|  <b>HYUNDAI</b><br><b>Technical Service Bulletin</b> | GROUP<br><b>BODY</b>          | NUMBER<br><b>18-BD-001</b>      |
| <b>SUBJECT:</b> SONATA (LFA) PANORAMIC SUNROOF REAR SEAL REPLACEMENT  |                               |                                 |

**Description:** This bulletin provides the repair procedure to eliminate panoramic sunroof creaking noise originating from the panoramic moving glass seal.

| Old Part Number<br>(81619-C1000)   | Improved Part Number<br>(81619-C1001)   |

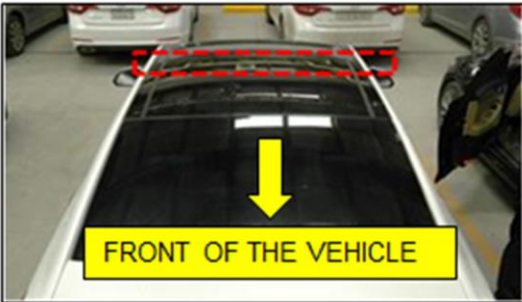
| Old Part Number<br>(81619-C1000)   | Improved Part Number<br>(81619-C1001)   |
|--|---|
|  <p>Solid</p> <p>Solid Single Extrusion</p> |  <p>Open Cell Foam      Solid</p> <p>Open Cell Foam and Solid Double Extrusion</p> |

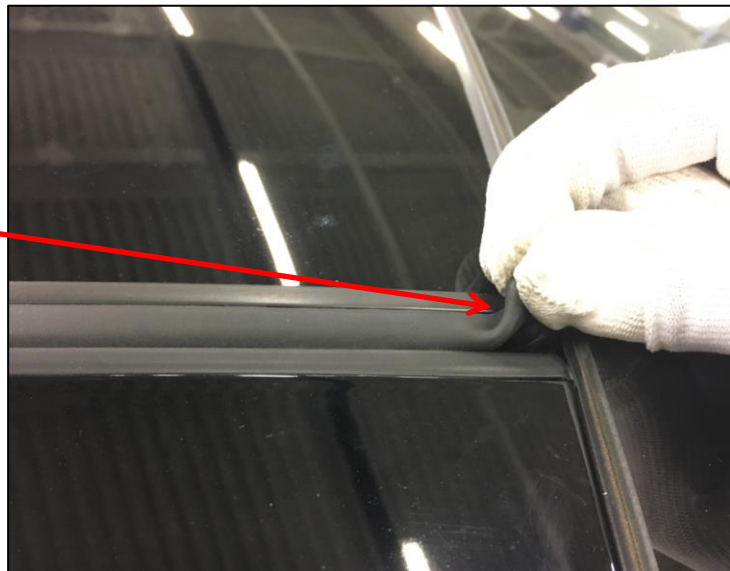
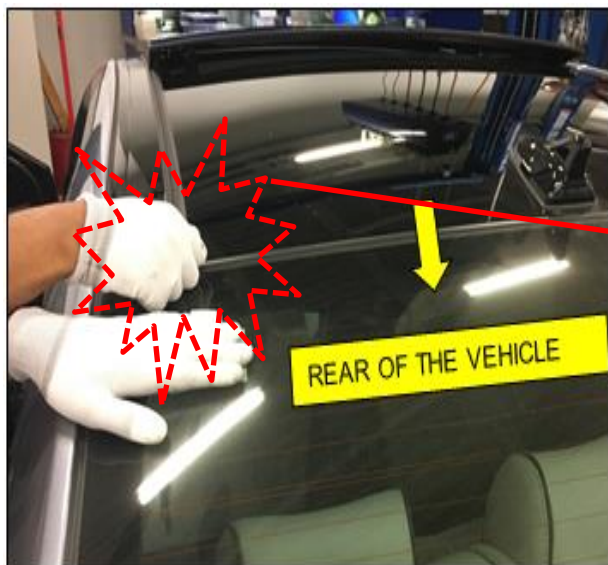
| 1. | <p><b>Condition:</b> Noise from panoramic sunroof area while driving. (“ticking” or “popping” noise)</p>   |    |
| 2. | <p><b>Location:</b> Noise can be heard at the center or rear of the panoramic sunroof glass.</p>   |    |
| 3. | <p><b>Confirmation:</b> Noise can be confirmed by tilting the sunroof glass up while driving.<br/>-&gt;If noise does not occur when moving glass is tilted up, the TSB does not apply.</p> | <div style="display: flex; justify-content: space-around;">   </div> <div style="text-align: center; margin-top: 5px;"> <span style="background-color: #4a7ebb; color: white; padding: 2px 5px;">Tilt Sunroof</span> </div> |

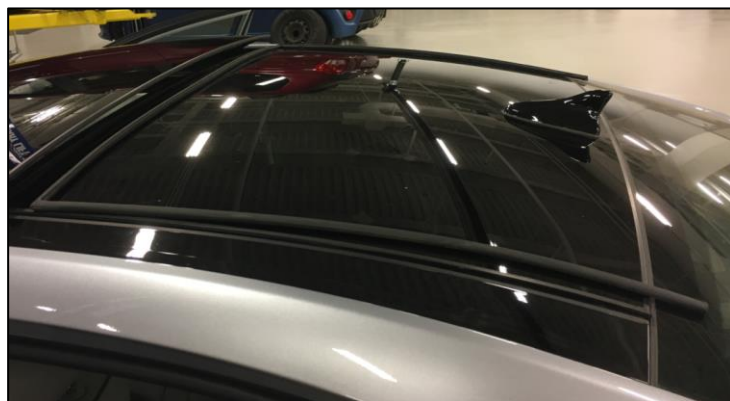
1. Remove the panoramic roof rear glass seal by gently pulling it from the fixed portion of the rear panoramic glass.

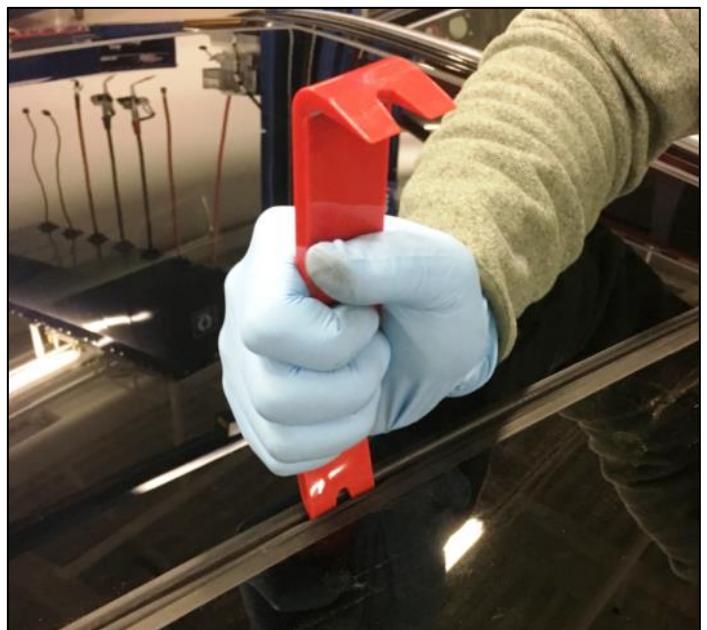
5. Set the corners of the replacement seal first to allow for proper alignment and installation.

6. Start by installing the end of the seal.
- Ensure that the groove in the seal is aligned with the groove in glass channel. Use a trim tool if necessary.

7. Confirm that the hole at end of the seal is pointed down and not visible.
